Subject: PTO Lock Out Upgrade 10/6/1997

Due to reported inconsistent effectiveness of the PTO reverse lockout from the field, BCS has updated the reversing mechanism for models 710 thru 850. This update can be retro fitted to earlier units. This retro fit should only be performed if the unit has experienced inconsistent PTO disengagement when shifting to reverse gear.

Model 710

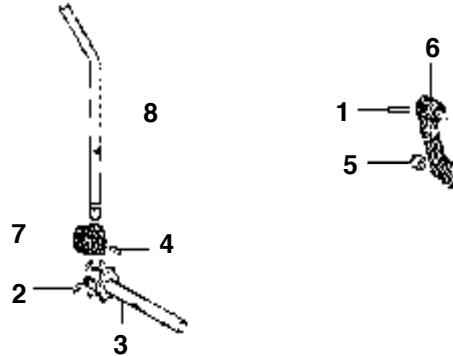
- 1) Remove roll pin (1) from existing PTO lockout lever and discard lever.
- 2) Remove roll pin (2) holding existing PTO control lever from PTO shaft (3). Remove control lever and remove roll pin (4) from existing stop ring. Discard control lever and stop ring.
- 3) Press PTO stop ring (5) on to PTO lockout arm (6) and install lockout arm on unit with roll pin (1).
- 4) Install new stop ring (7) on new PTO control lever (8) locking into position with roll pin (4). Install control lever into position on PTO shaft (3) with roll pin (2).

Model 716 - 730

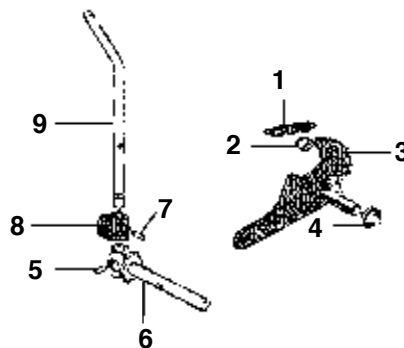
- 1) Remove rear cover.
- 2) Remove gears to expose slider lever for reversing gear. Remove roll pin holding slider lever into position.
- 3) Remove reverse lever return spring (1) and reverse lever. Discard reverse lever.

- 4) Press PTO lockout ring (2) on to new reverse lever (3). Inspect o-ring (4) for reverse lever and replace if necessary. Install reverse lever (3) and reattach return spring (1).

- 5) Install slider lever for reversing gear and lock into position with roll pin.
- 6) Install gears and rear cover sealing with gasket material.
- 7) Remove roll pin (5) holding existing PTO control lever from PTO shaft (6). Remove control lever and remove roll pin (7) from existing stop ring. Discard control lever and stop ring.

- 8) Install new stop ring (8) onto new PTO control lever (9) locking into position with roll pin (7). Install control lever into position on PTO shaft with roll pin (5).

Model 830 - 850

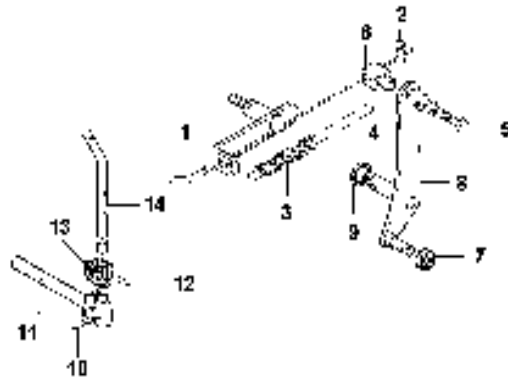
- 1) Release reverser cable (1) by removing cable clamp (2).
- 2) Remove reverser spring (3) and guide pin (4) by removing bolt (5) in guide block (6).

- 3) Remove rear cover.
- 4) Remove gears to expose slider lever for reversing gear. Remove roll pin holding slider lever into position.
- 5) Remove reverse lever and discard.

- 6) Press PTO lockout ring (7) on to new reverse lever (8). Inspect o-ring (9) for reverse lever and replace if necessary. Install reverse lever (8).
- 7) Install slider lever for reversing gear and lock into position with roll pin.

- 8) Install gears and rear cover sealing with gasket material. Install reverser spring (3) and guide pin (4). Install and adjust reverser cable (1).
- 9) Remove roll pin (10) holding existing PTO control lever from PTO shaft (11). Remove control lever and remove roll pin (12) from existing stop ring. Discard control lever and stop ring.

- 10) Install new stop ring (13) onto new PTO control lever (14) locking into position with roll pin (12). Install control lever into position on PTO shaft with roll pin (10).

Illustration 2

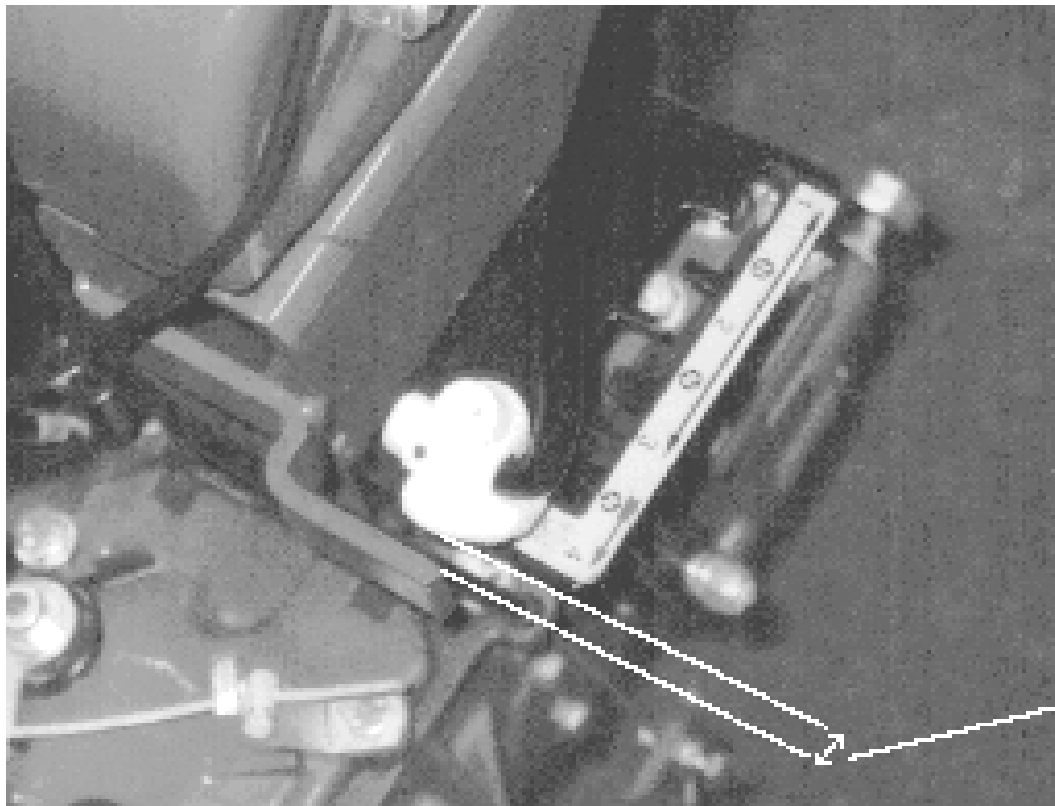
A 2mm to 6mm Gap should exist between the articulator and stop bracket

We are requesting that all the units be checked for the incorrect decal and gap adjustment. If a tractor has the incorrect decal, the correct decal (p/n 580.57706) should be ordered. This decal will be sent as a no charge order to correct this situation.

To adjust the gap between the articulator and stop bracket, strike the stop bracket with a hammer and bend into position.
